BOARD ACTION REPORT – APPEALABLE ITEM

Project Name: Tzikas Medical Center (2019-035)

SITE PLAN REVIEW AND APPEARANCE BOARD STAFF REPORT

Application Type: Class III Site Plan
Modification for Tzikas Medical Center

1 PROPOSED SITE PLAN
1"=10'-0"

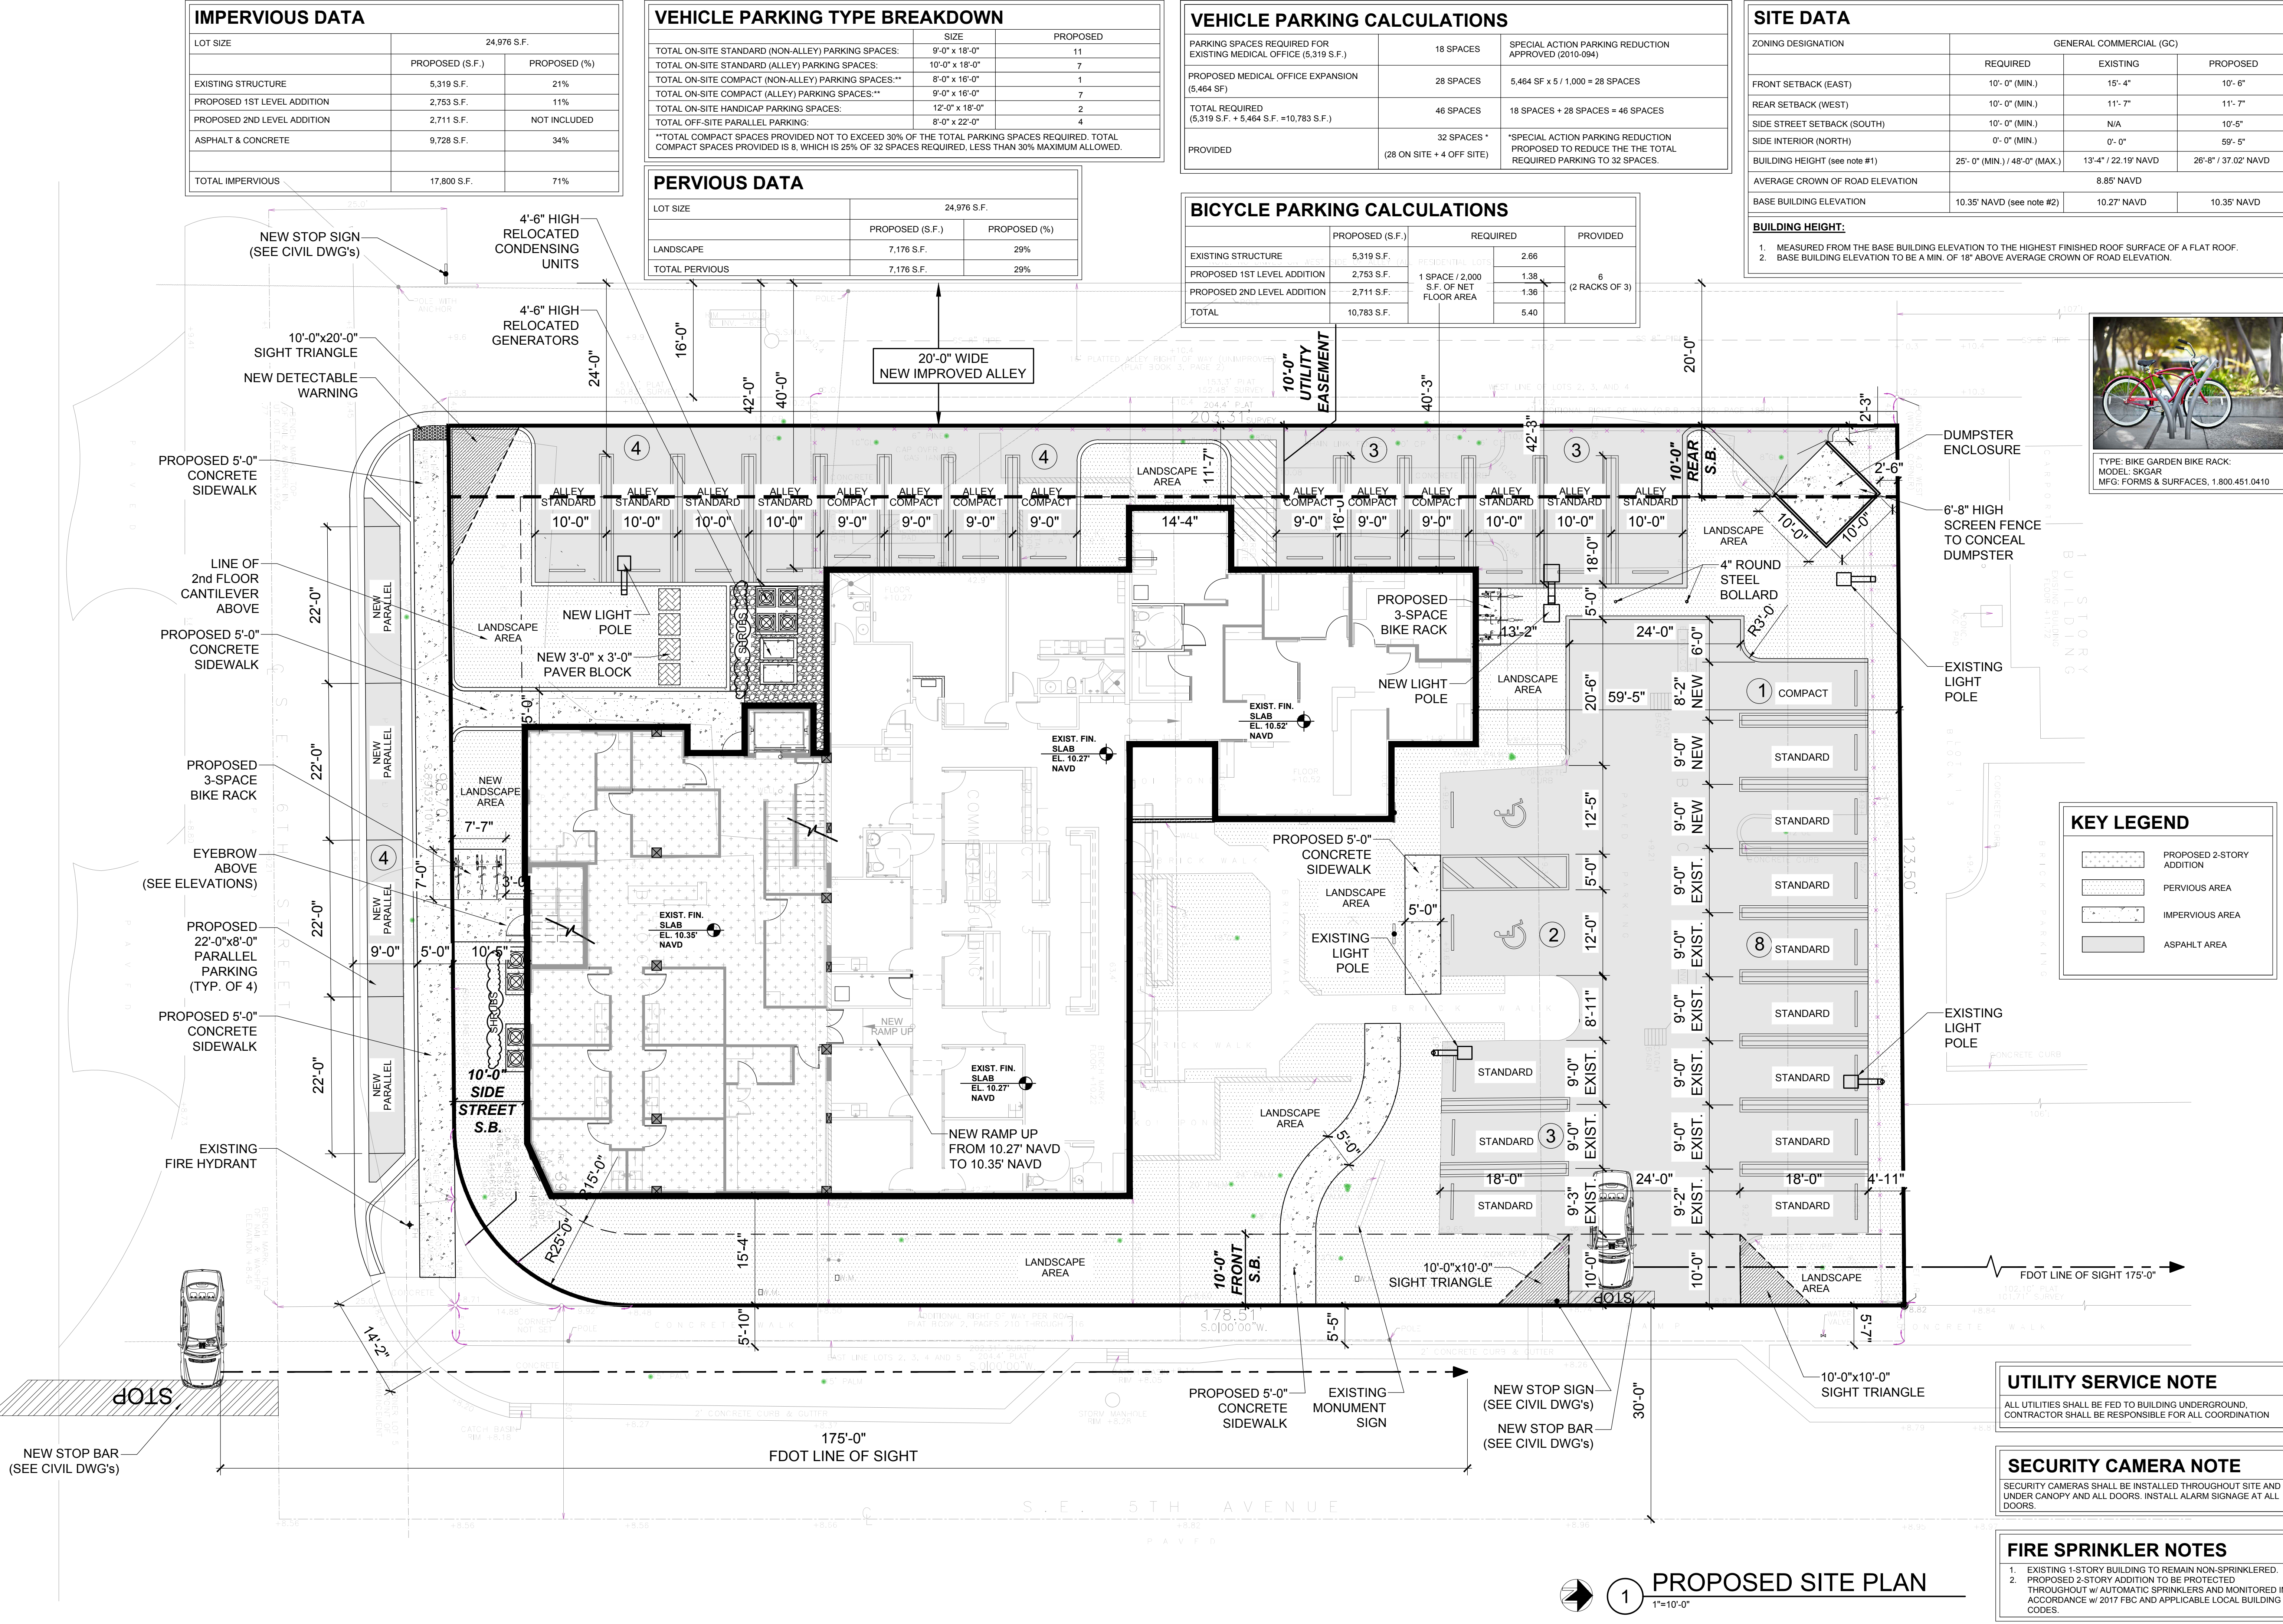
- The planting area separating the parking spaces adjacent to the alley and the maneuvering area located within the dead-end parking lot shall be revised to provide a planting strip of no less than five feet in width. The proposal shall be revised to comply with this requirement prior to certification of the plans.

As depicted on sheet SP-1, the alley and alley compact space combined depth is 40'-0". This condition applies to (7), alley compact spaces that are shown at 9'-0"x 16'-0". The applicant has specifically selected this area for the 2'-0" depth reduction as it is centrally located and does not impair sight distances of pedestrians and/ or vehicles. Granting this request will not diminish the practical application of LDR Section 4.6.9(D)(2)(b) and will result in a superior development for the surrounding community.

Approval of the proposal would include acceptance by the Site Plan Review and Appearance Board that the internal adjustment relief requested by the applicant is constitutes a superior product than if the project were to comply with the letter of the regulations.

Landscape Development Plan

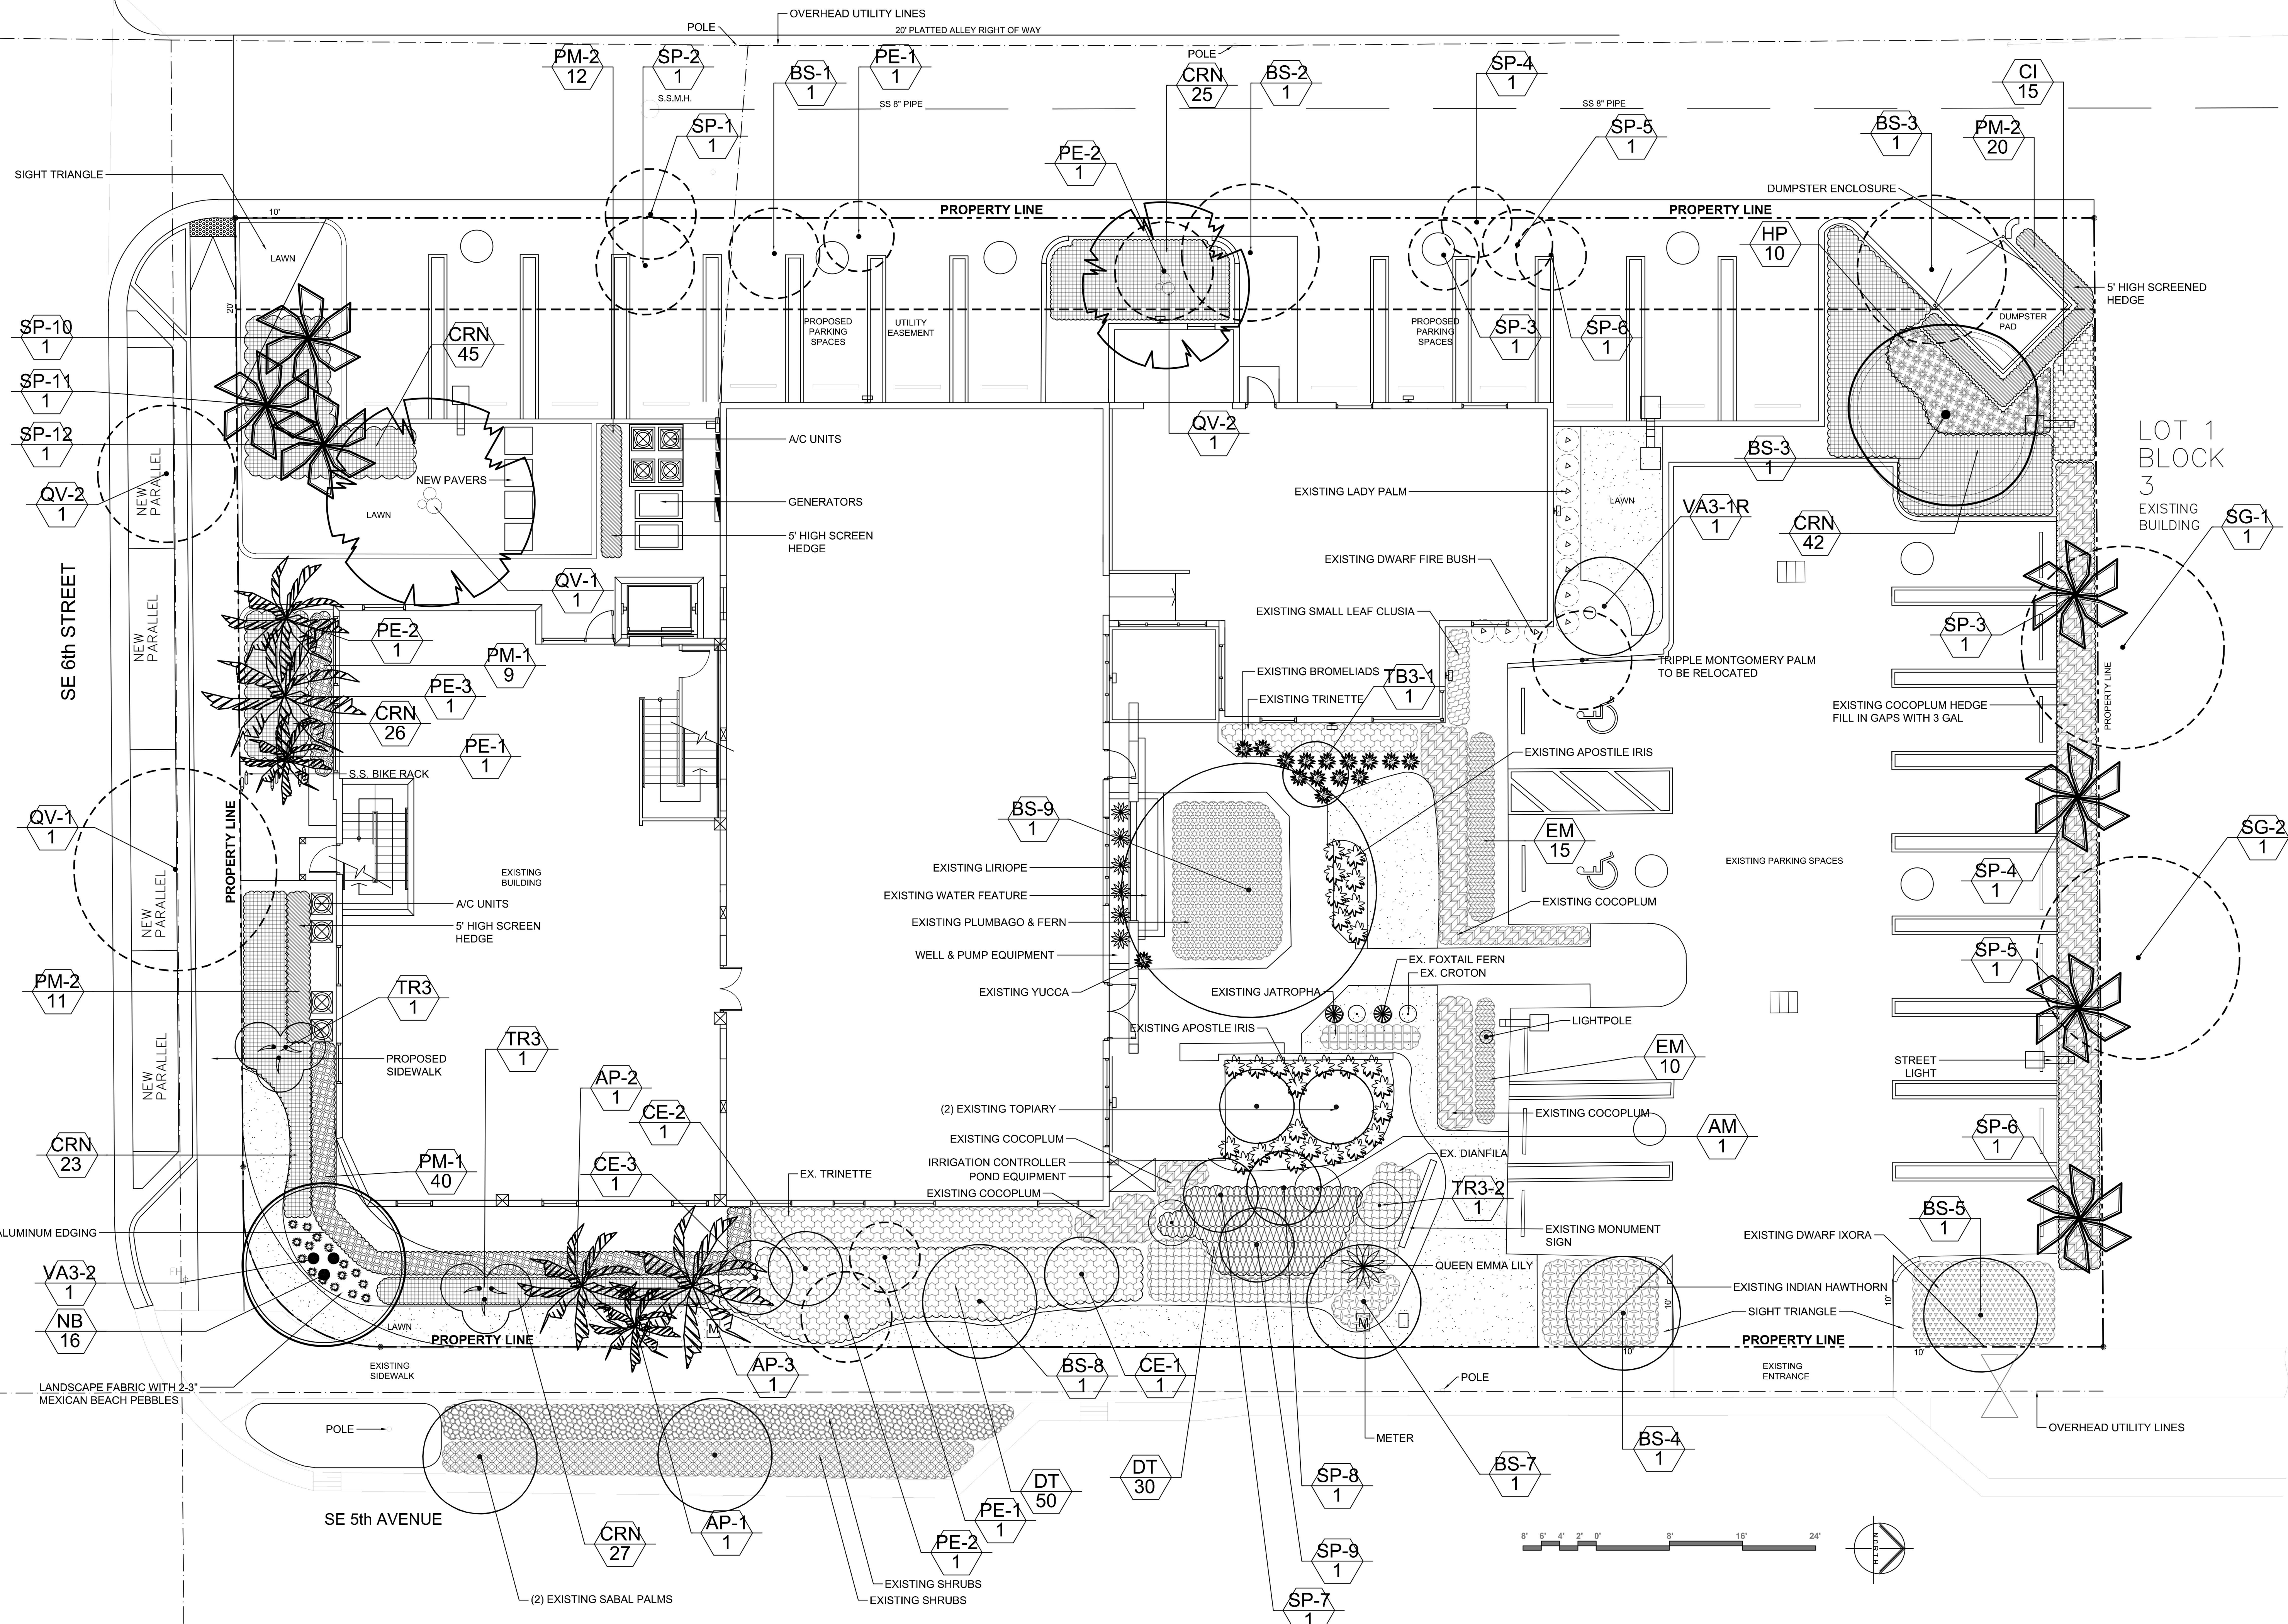
LDR Section 4.6.16(H)(3)(d) a landscaped barrier shall be provided between the off-street parking area or other vehicular use area and abutting properties. The landscape barrier may be two feet at the time of planting and achieve and be maintained at not less than three nor greater than six feet in height to form a continuous screen between the off-street parking area or vehicular use area and such abutting property. This landscape barrier shall be located between the common lot line and the off-street parking area or other vehicular use area in a planting strip of not less than five feet in width that is free of any vehicular encroachment, including car overhang. The planting area separating the parking spaces adjacent to the alley and the maneuvering area located within the dead-end parking lot measures 5ft from the face of the curb; per this requirement, the planting strip shall be no less than five feet in width. The proposal shall be revised to comply with this requirement prior to certification of the plans; if additional width is needed, the proposal allows for the conversion of one additional standard parking space to compact(8, or 25%, of a total of 32 spaces are currently proposed as compact and a maximum of 9 ,or 30%, compact spaces are allowed).
